RUSSIAN FEDERATION
MINISTRY OF TRANSPORT OF RUSSIAN FEDERATION
FEDERAL AIR TRANSPORT AGENCY
AIRWORTHINESS DIRECTIVE

No. 2022-AHCAT, AHCAT-K-03

Applicability – ANSAT helicopters (ANSAT, ANSAT-GC models), ANSAT-K helicopters (ANSAT-K model) and their modifications

TECHNICAL DECISION No. 2/144-2021-KB3
on continued airworthiness of ANSAT helicopters (ANSAT, ANSAT-GC models),
ANSAT-K (ANSAT-K model) and their modifications
Revision 2

Figure 1

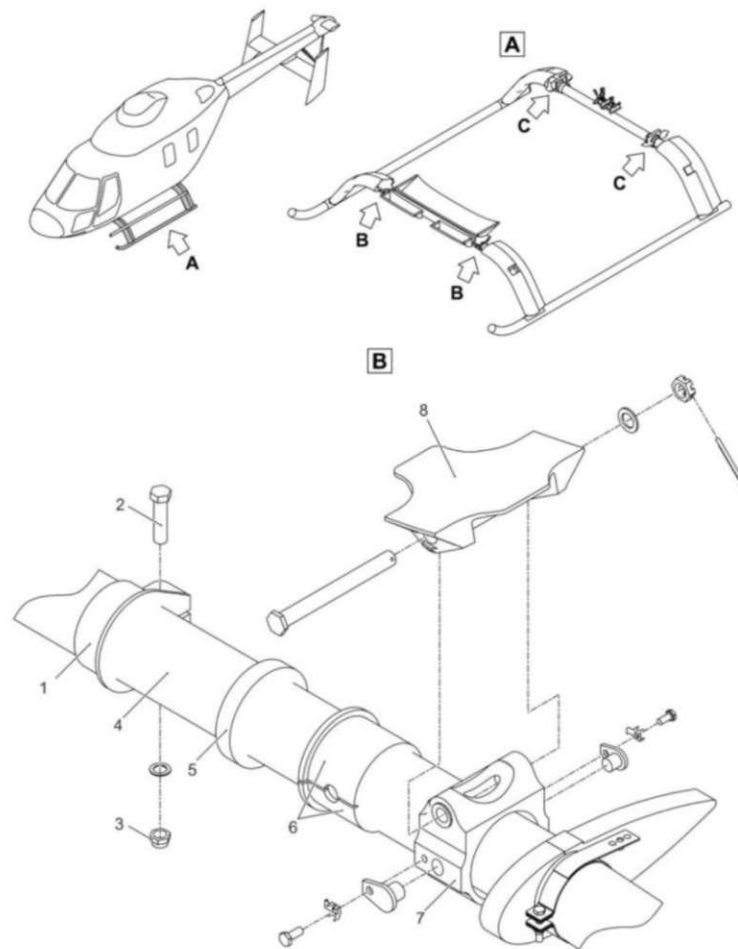
Temporary task card 032.00.00 i	
Procedure: Monitoring of the landing gear position	
Operations and technical requirements	Corrective actions
<p>1. Perform the preparatory works:</p> <p>1.1. Lift the helicopter using jacks;</p> <p>1.2. If necessary, for the convenience of carrying out the works, remove the fairings of the forward and aft cross-over tubes;</p> <p>2. Level the helicopter according to the section 008.10.00;</p> <p>Proceed as follows if the landing gear position parameters exceed the tolerance limits:</p> <p>2.1 Loosen the nuts (3) of bolts (2) of coupling clamps (1) on the forward or aft cross-over tubes (4);</p> <p>2.2 Move the coupling clamps (1) and rubber rings (5) by 50 mm closer to the center of the cross-over tubes;</p> <p>2.3 Perform landing gear positioning, move its forward and aft cross-over tubes relative to the lateral axis of the helicopter until the required parameters are reached;</p> <p>2.4 Move the rubber rings (5) and coupling clamps (1), having tightly pressed them to the rings (7) of cross-over tubes (4) hinging, without moving the cross-over tubes themselves;</p> <p>2.5 Tighten the nuts (3) of coupling bolts (2) of clamps using torque wrench with torque of 3.5 kgf·m;</p> <p>3. Perform the final works;</p> <p>3.1. Install the fairings of landing gear cross-over tubes;</p> <p>3.2. Lower the helicopter from jacks.</p>

Figure 1

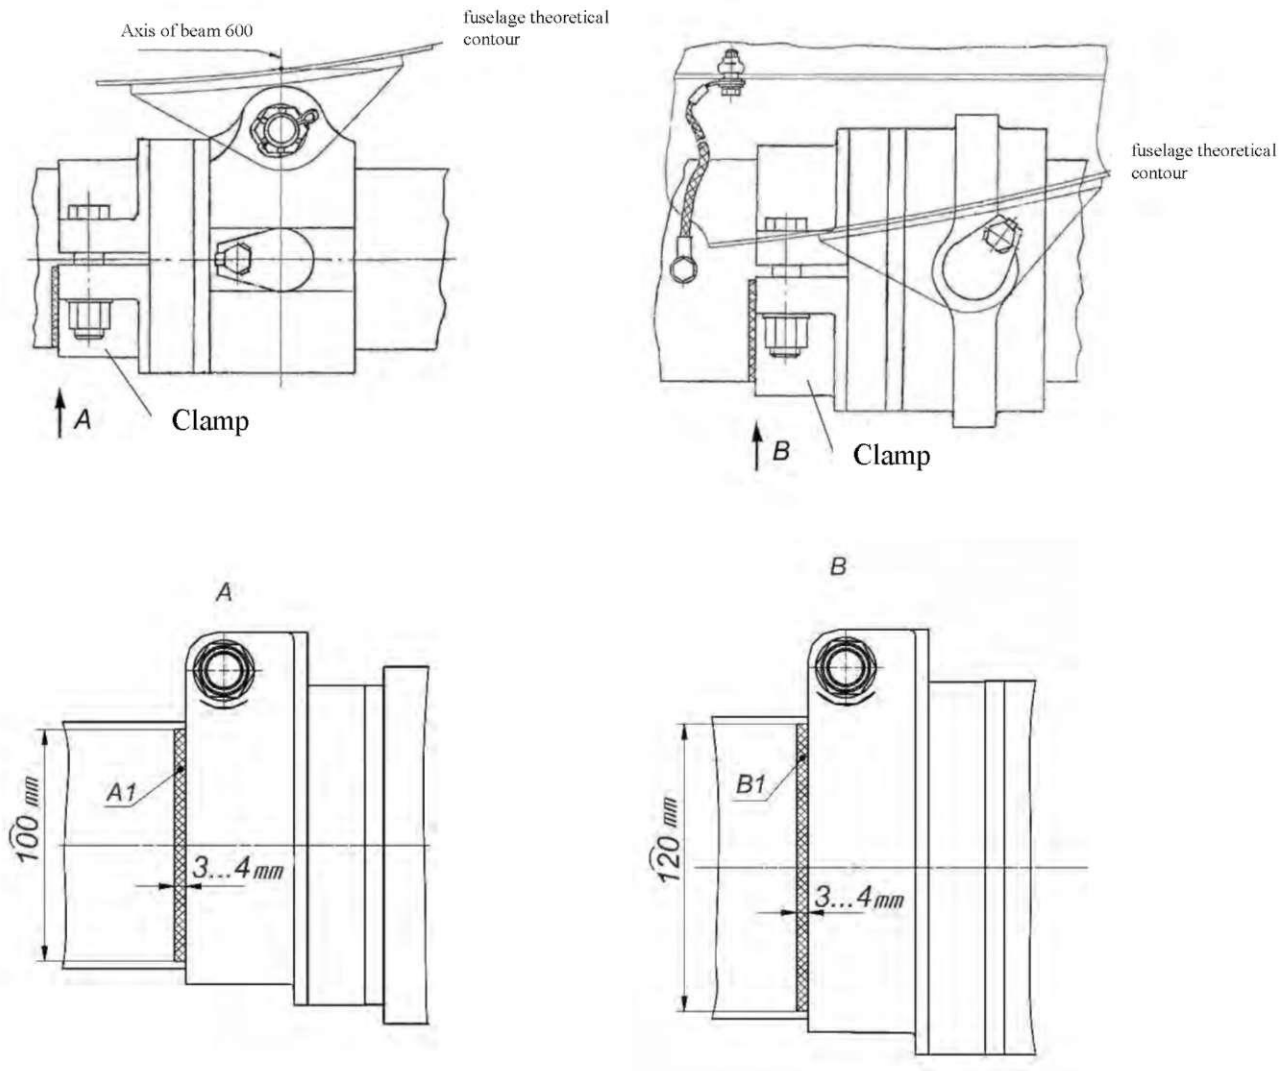
1.1.3 Apply check marks on the landing gear cross-over tubes using the ЭП-140 enamel of red color in accordance with Figure 1 (Appendix 2);

Apply check marks A1 and B1 to the surfaces of the cross-over tubes along the edges of clamps using ЭП-140 enamel of red color per ГОСТ 24709 standard, 2 layers (on the portside and starboard).

1.1.4 Establish the intervals of monitoring the position of the clamps relative to the check marks - every 50 ± 5 landings. In case of detection of displacement of clamps relative to the check marks to a distance of more than 4_{-1} mm (check mark width) – perform operations in accordance with the p. 1.1.1 of present Decision and inform the JSC “Kazan Helicopters”.
